ADDENDUM - REVISED 3/31/10

GENERAL NOTES, TYPICAL SECTION & SUMMARY OF QUANTITIES

F.A.I. SECTION COUNTY TOTAL SHEET NO. 57 [(46-3)HB-6]I KANKAKEE B 2 CONTRACT NO. 66A01

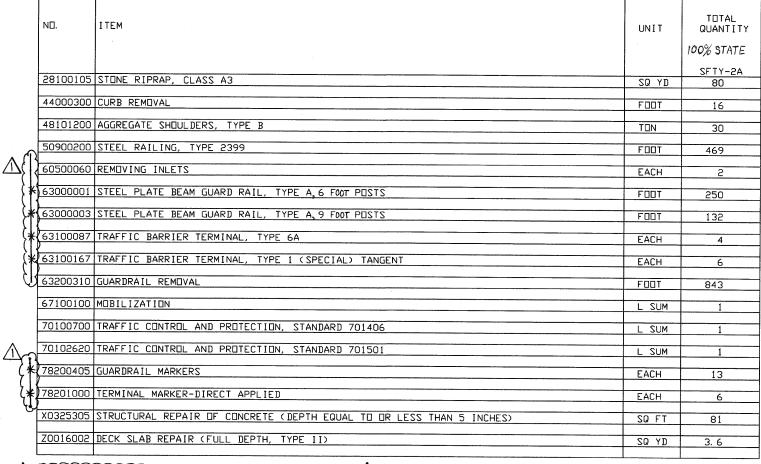
THE CONTRACTOR SHALL PLACE STONE RIPRAP CLASS A3 AS DIRECTED BY THE ENGINEER TO REPAIR SLOPE WASHOUTS. LT. & RT. STA. 21+00 TO STA. 21+50
